Architectural Review Board

Staff Report

Subject: 2500 El Camino Real [13PLN-00161]: Request by Stanford Real Estate for Preliminary Architectural Review of a proposed four-story mixed use project with 70 residential units (one, two and three bedroom units) of below market rate rental housing and approximately 7,300 square feet of commercial space. Zone: CS (AS1).

2500 El Camino Real [13PLN-00161]

CALTRANS TYPE 15TS (MOD)

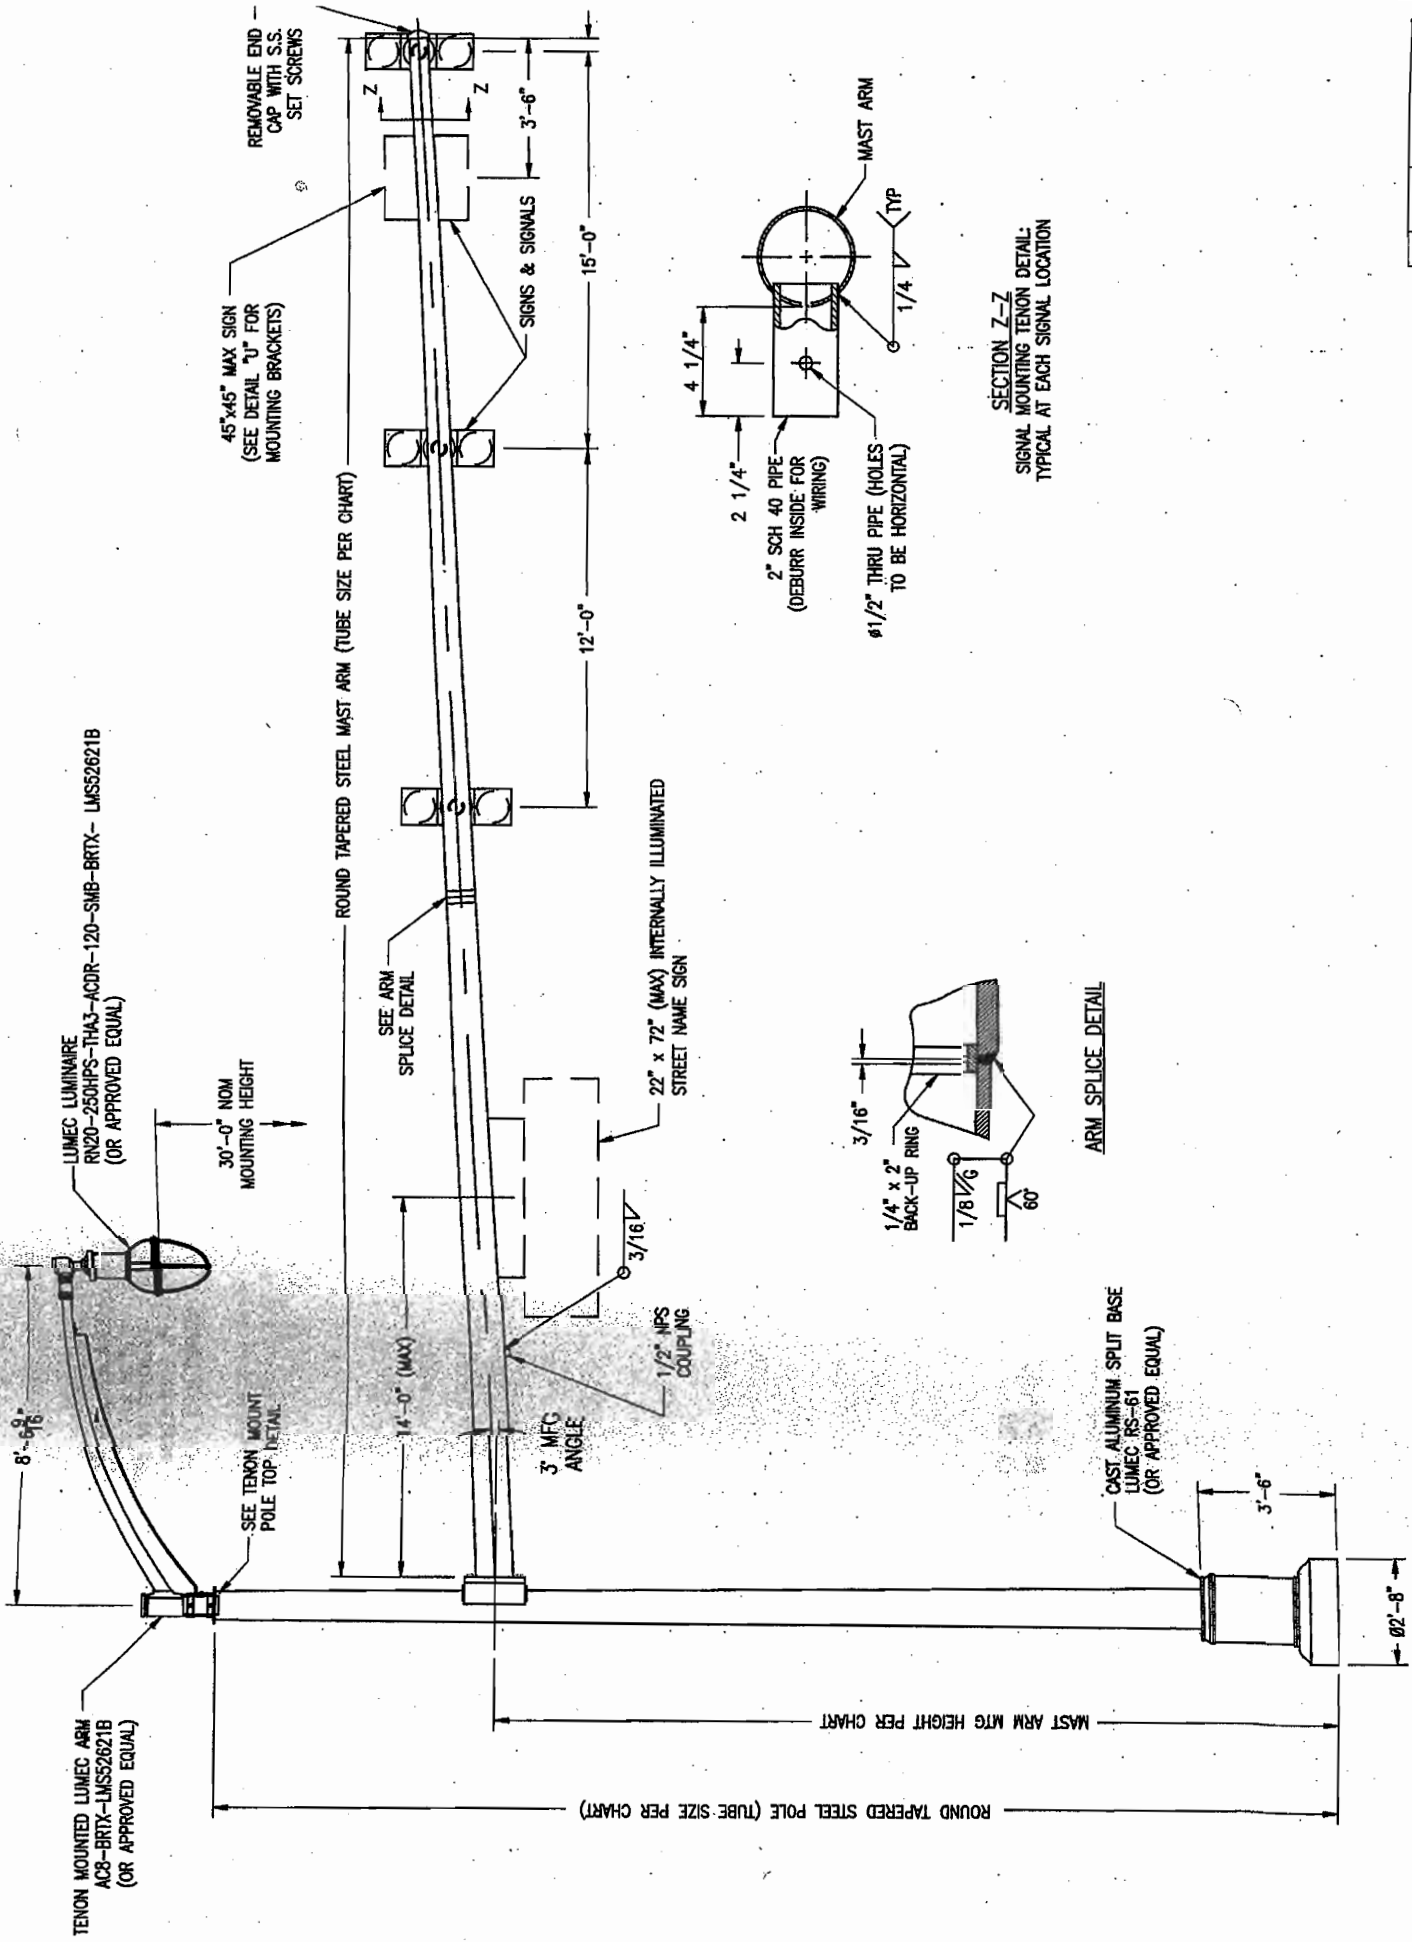
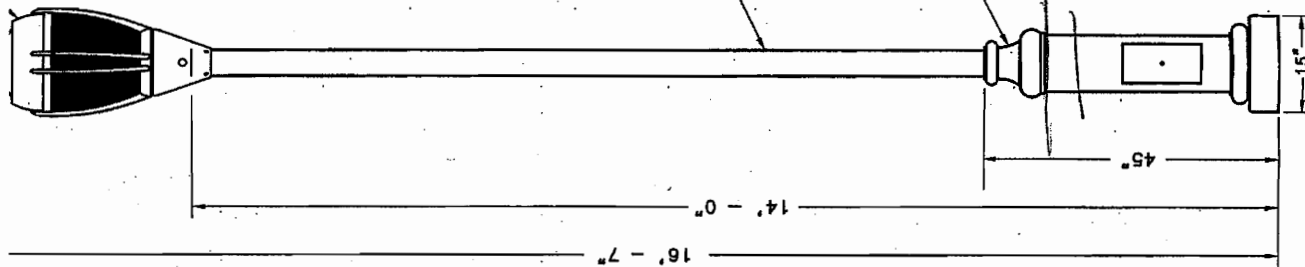
Note that we are asking that they replace the street lights in the right of way on El Camino with the same models that were used at the Stanford Ave/El Camino streetscaping demonstration project and fill in the gaps between the existing street light locations with pedestrian scale lights. I have attached the specs for the lights and also included them in the comment packet I provided the applicants at the DRC meeting. Note that these lights went through ARB review for the Stanford Ave/El Camino streetscaping project.

COLOR: ~~BRONZE~~ Textured Bronze
